BAR meeting September 20, 2022

Certificate of Appropriateness (Prelim Discussion*)

0 3rd Street NE, TMP 330020001

Project: New residence on vacant lot

SITE PLAN - SCHEME C
GROUND FLOOR

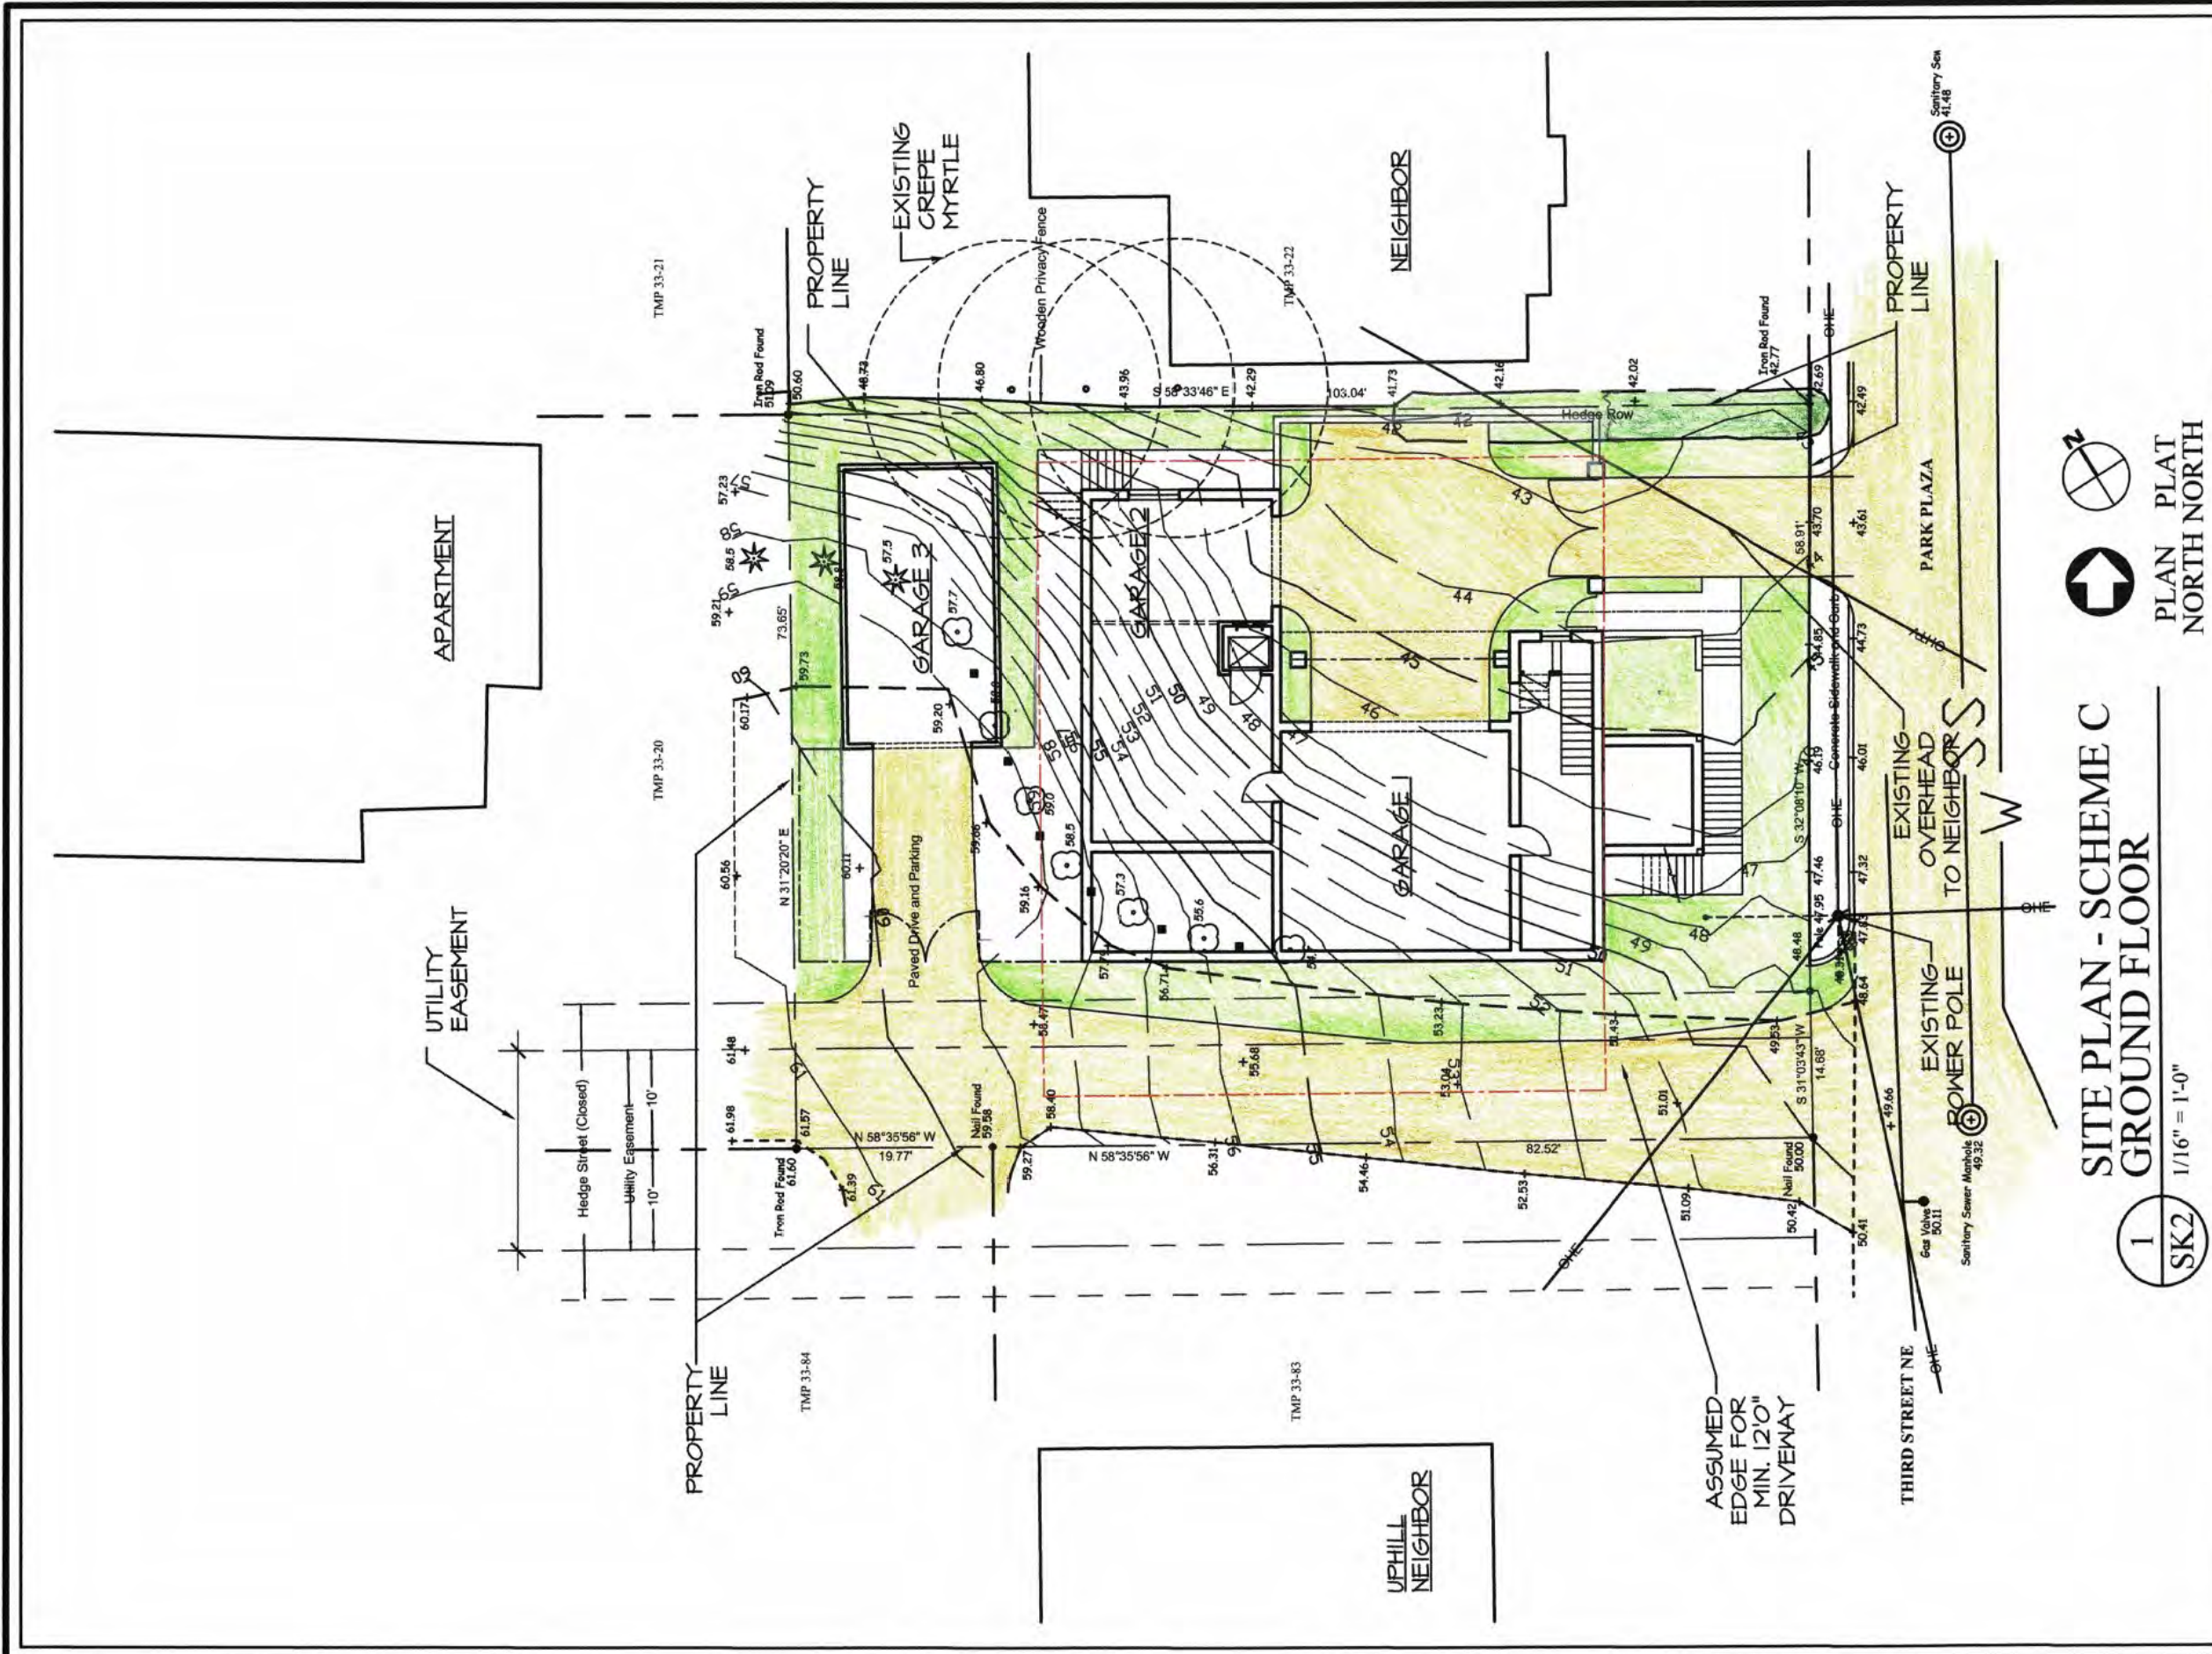
Staff Comment: Front setbacks range between 6 feet and 55 feet, with an average of 18 feet. Recommended range for new is 19 feet to 28 feet. The proposed setback is approximately 21 feet, within the recommended range.

Staff Comment: Side spacing ranges between 6 feet and 50 feet, with an average of 15 feet. Recommended range for new construction is 12 feet to 19 feet. The proposed spacing (north side) is approximately 30 feet, which exceeds the recommended spacing; however, it is within the range of existing spacings and not out of character with the subarea. (Note: The spacing on the south side is dictated by an existing access easement.)

Staff Comment: Due to the site's topography and the easement to allow neighbors continued use of the existing side driveway, the front driveway (north side) is necessary to allow access to the primary garage.

ELEVATIONS -
SCHEME C

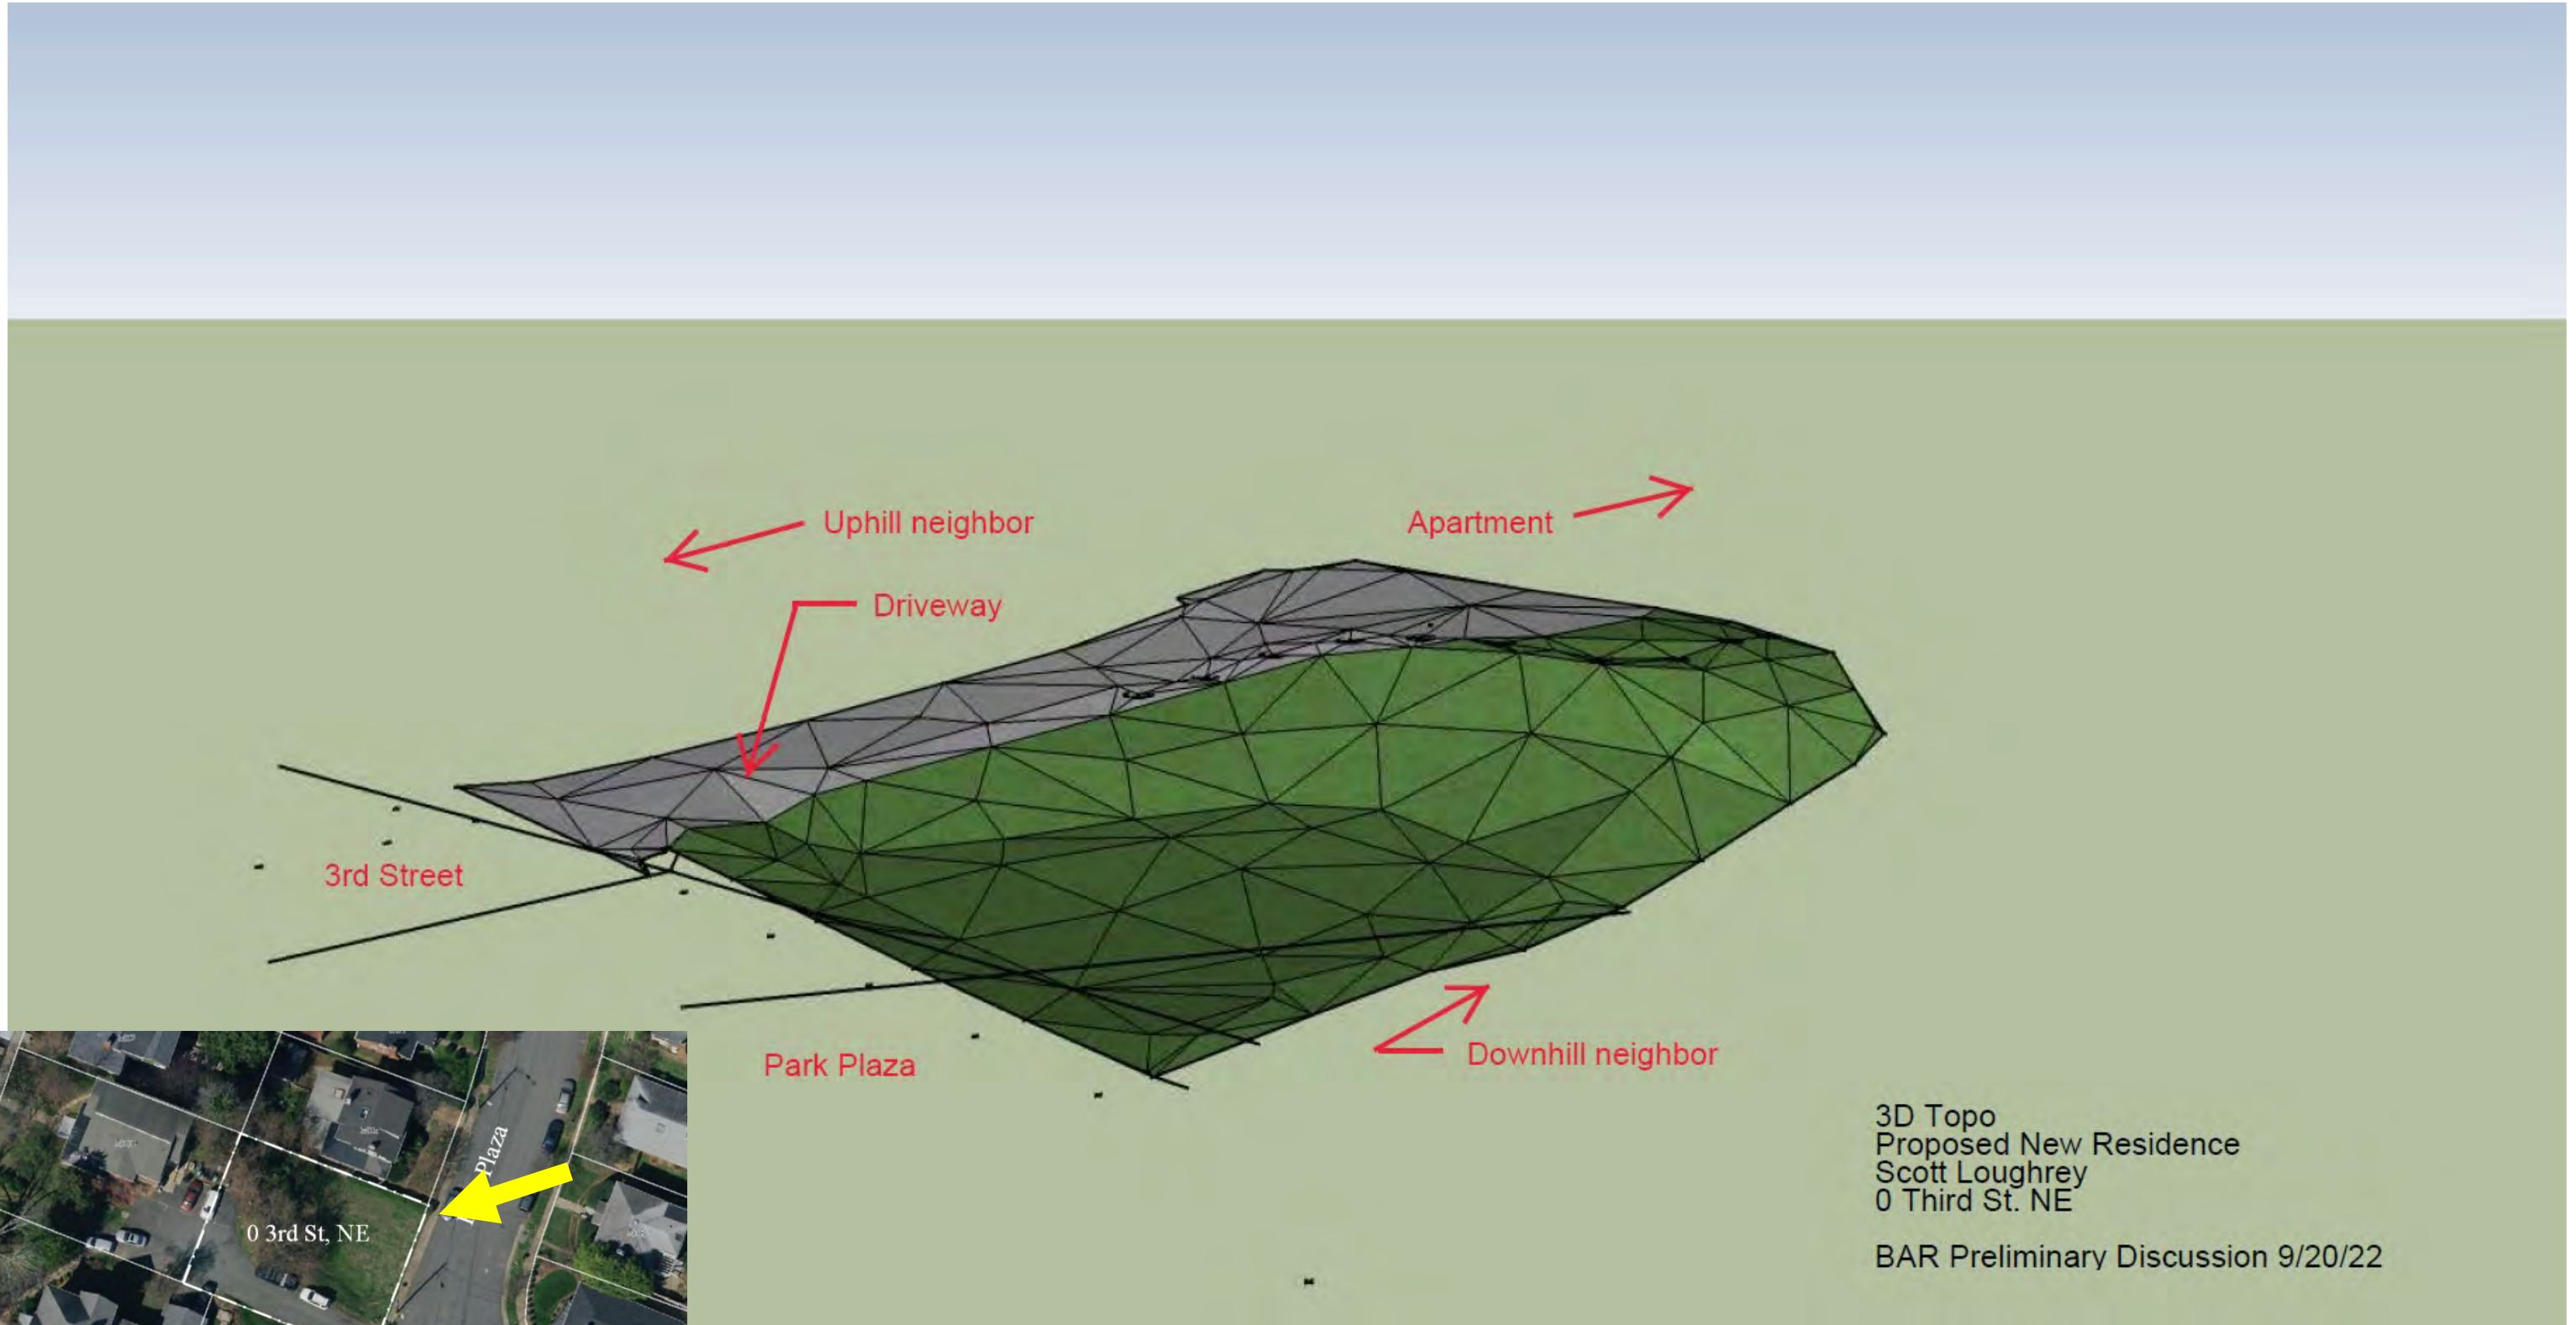
The foundation of the new house will be brick and feature banding that distinguishes it from the upper walls. A prominent element of the house is the elevated front porch and two sets of stairs from the sidewalk. Given the topography of North Downtown, this is not uncommon within the adjacent subarea. 14 of the nearby houses have seven or more steps from the sidewalk to the front porch; eight have 13 or more; three have at least 22 steps; on; six houses have fewer than three steps.

As rendered, the cornice features a frieze board, soffit, and fascia; however, the detail, dimensions, and material have not been finalized.

Staff Comment: As rendered, the details and ornamentation are not finalized, but are generally in character with the surrounding houses, which have such a broad range of architectural styles there are few *typical features*. The proposed brick banding is similar to the brick bands at 430 1st Street and also reflects the horizontal trim elements at 413 2nd Street and 418 4th Street.
